29 March 2019

Our Ref: 16-0011Kcmc1_v2

**Re: One Carrington Street Project Section 4.55 Application (s4.55)—
Beneficial House Roof Slab Demolition—Heritage Impact Assessment**

Figure 6 Detail of the southern parapet gable end wall to the tiled roof. (Source: GML 2018)

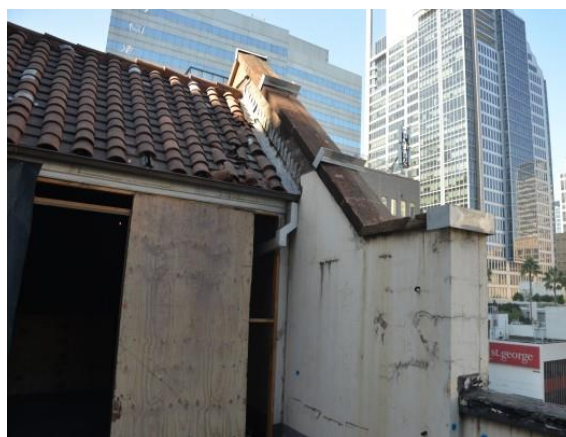
- Stability of the parapet end walls—The 2015 SOCW included repair of the brick chimneys and parapet gable brick and stone, etc. We understand that structural detail is being designed to support these walls during removal of the timber (tiled) roof structure and roof slab, and in the new design.
- Stability and integrity of the perimeter parapet walls—We understand that the general relationship between the roof deck and other new structures has not changed from the approved design, but that fixings of the new steel structure to the walls will be required.

- additional structural support will be required for the parapet walls, end gable walls (to the tiled roof) and retained rooftop structures; and
 - the proposed roof slab demolition and the condition of the tiled roof structure requires that this timber framed (tiled) roof structure, dating from the 1920s, is removed, but cannot be reinstated using original fabric.

Figure 8 Section showing approved roof works at the rooftop level. (Source: Make, drawing number -A-285-21-32-1, October 2016)

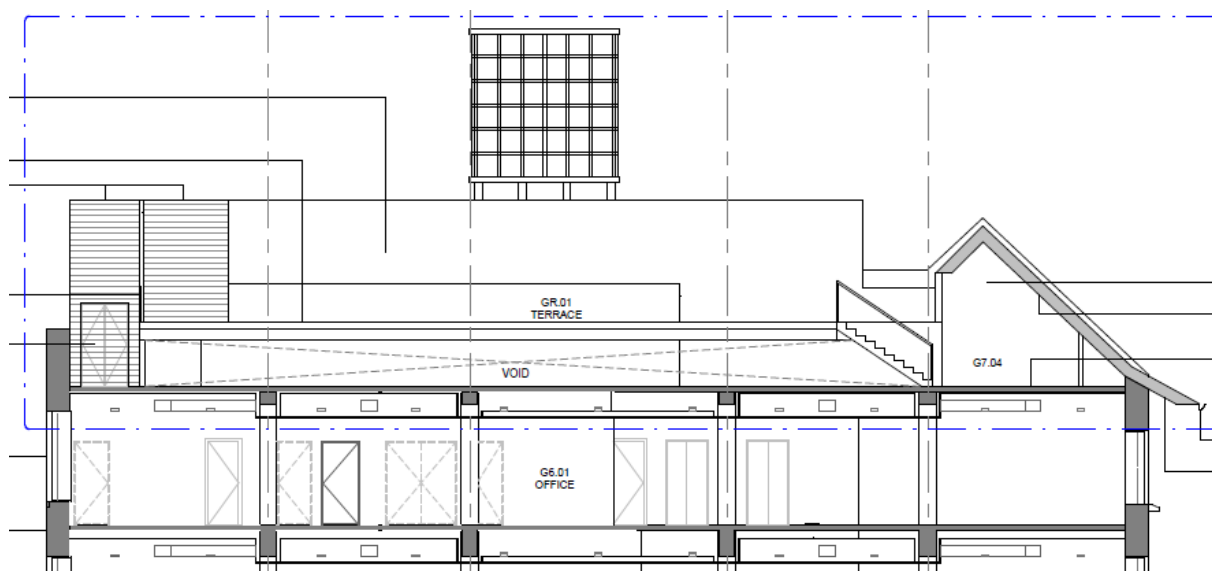
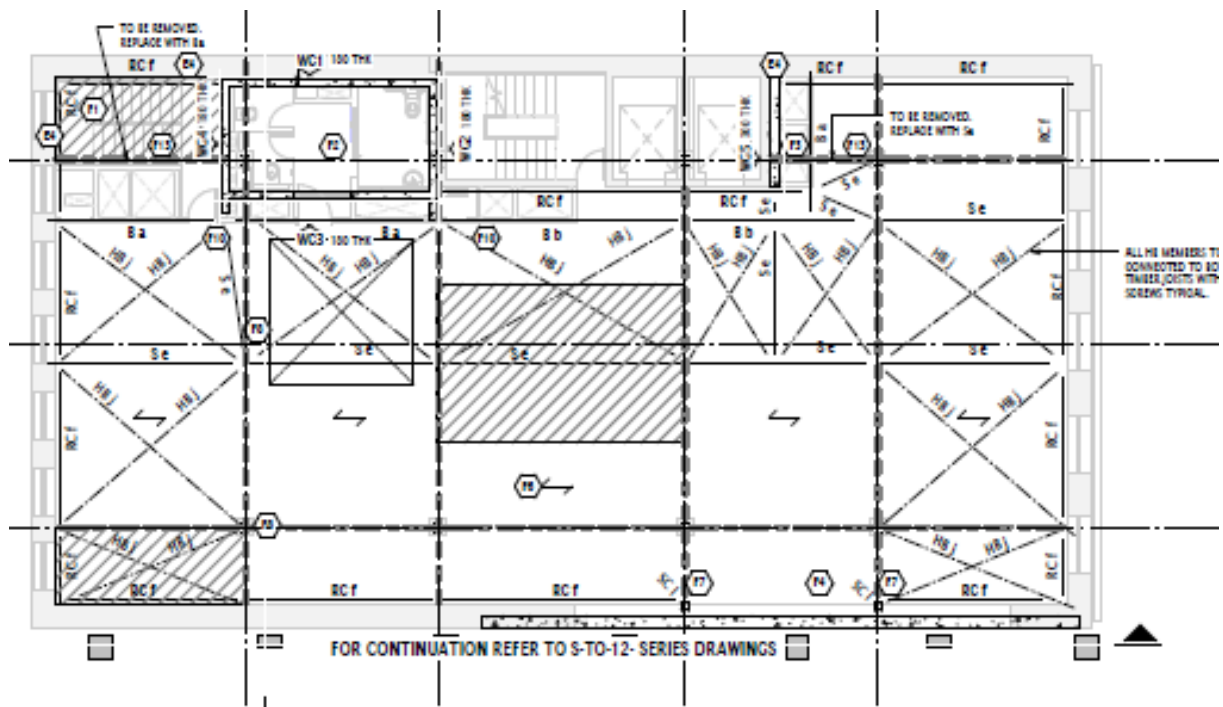
- The proposed steel roof does not represent an increase in height from the approved main deck area. Visual impacts of the new multi-layered roof structure and main deck, tiered planter, new planter in the water tank and additional viewing deck on the remaining stair and lift tower will not change from the approved scope of works. Refer to Figures 8, 9 and 24. These changes will not be visible from the street.

Figure 11 Proposed extent of roof slab demolition, shown in hatched red. (Source: TTW, drawing number ST-285-10-00-50, Rev C 27.03.2019)

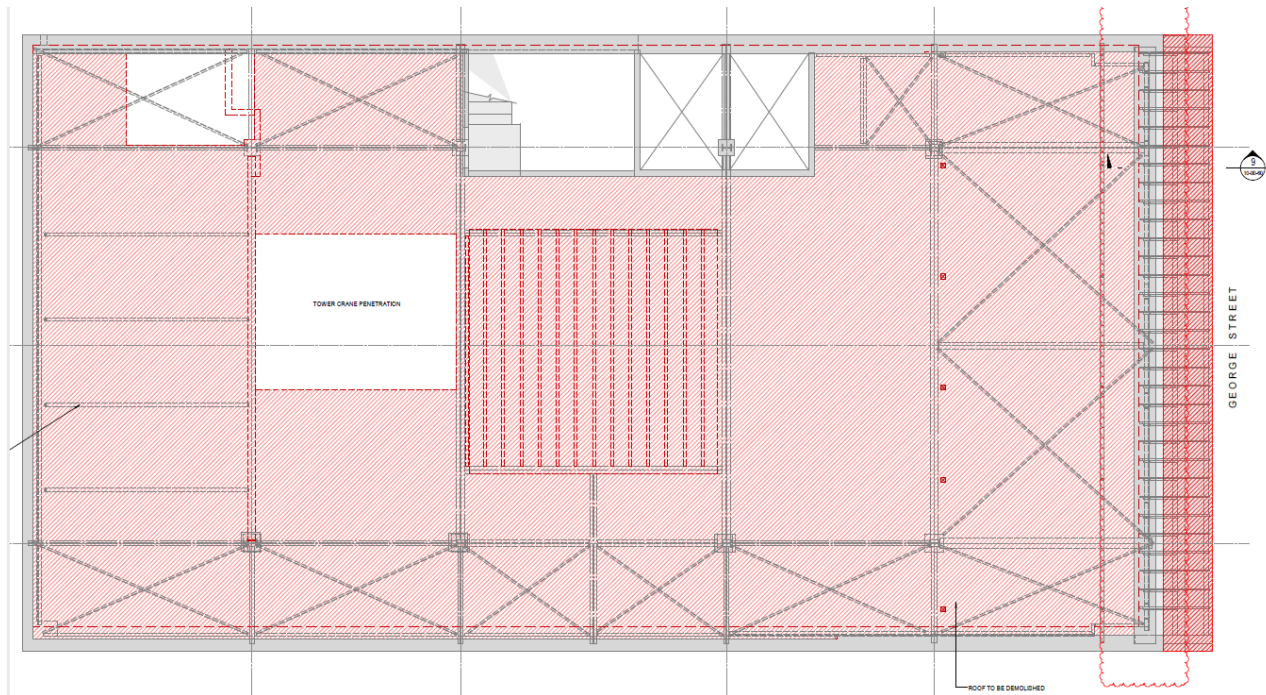
- Demolition process—The demolition process and fixing of the replacement roof structure could involve additional impact on original significant building fabric that will, cumulatively, result in loss of further heritage fabric, integrity of the remaining roof features, and therefore compromise the significance of the building overall. Construction measures will need to be implemented to address the potential impact of demolition on the interiors, brick parapet walls, gable end parapets and decorative cornice to avoid damage to this fabric.

- Demolition of the projecting slab soffit, support for the existing brick and render cornice to the George Street façade and replacement with a new soffit (steel structure) to visually match—Retention and protection of the cornice is considered essential as it is an architectural feature of high significance. Impacts which compromise or result in damage to, or the complete loss of, the decorative cornice detail should be avoided. Temporary support measures should not otherwise damage the buildings integrity.

- Developing structural detail and construction methodology regarding the extent of demolition should avoid or minimise risk to significant fabric so there are no additional adverse heritage impacts, in particular the projecting cornice, parapet walls and spaces below. Heritage considerations include:

- Support for and protection of the decorative brick and render cornice to enable removal of the adjoining slab and overall insitu conservation of this architectural feature;

Figure 11a Section detail showing in red hatching, the proposed extent of demolition and the remaining section of existing slab over the George Street wall and over the decorative cornice. (Source: TTW drawing number -ST-285-10-00-60, issue C 27.03.2019)

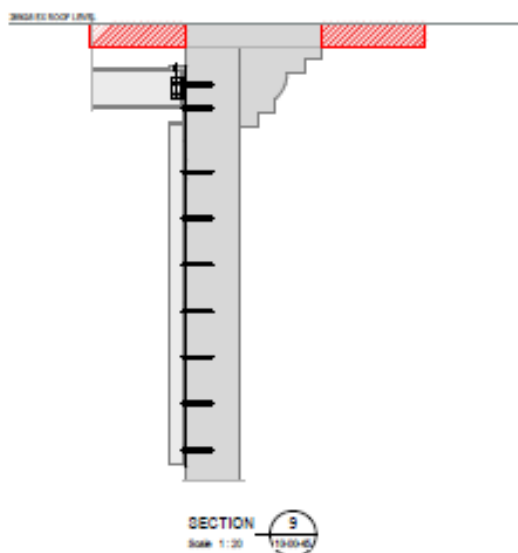
The proposed changes involve the removal of the roof slab, including the projection over George Street, but retaining in the first instance a long section of slab over the George Street façade and the existing decorative brick and render cornice. The cornice will then be supported by temporary vertical steel beams and the projecting roof slab is subsequently removed and replaced by a new multi-layered steel framed roof structure, including a steel projection over George Street.

Figure 13 Proposed new roof section, detail at eastern boundary at tiled roof and cornice. Note: the detail of the projecting soffit is currently under design review. (Source: Make, drawing number -285-51-02-1, issue 4 [for information], 6 March 2019)

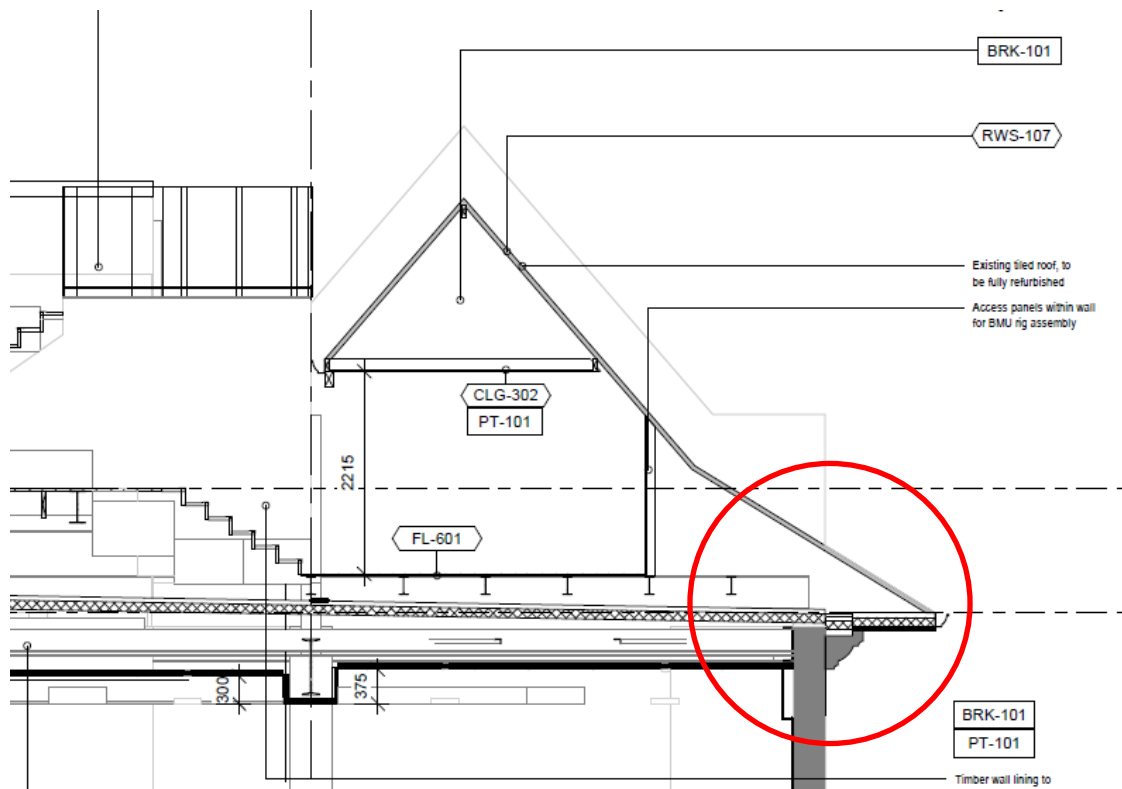
- Demolition and replacement of the 1920s timber (tiled) roof structure above the George Street façade—The timber roof structure necessarily needs to be dismantled to allow for the roof slab demolition and replacement. Given the condition of the roof timbers, it is not viable to reconstruct this structure using the same fabric. The proposed new roof structure should be an exact replica of the demolished roof structure including timber structure and roof design. The existing original

- The tiled roof replacement structure should be designed to match the original demolished roof structure exactly in regard to size, form, materials and construction detail. Measured drawings should be prepared prior to demolition.
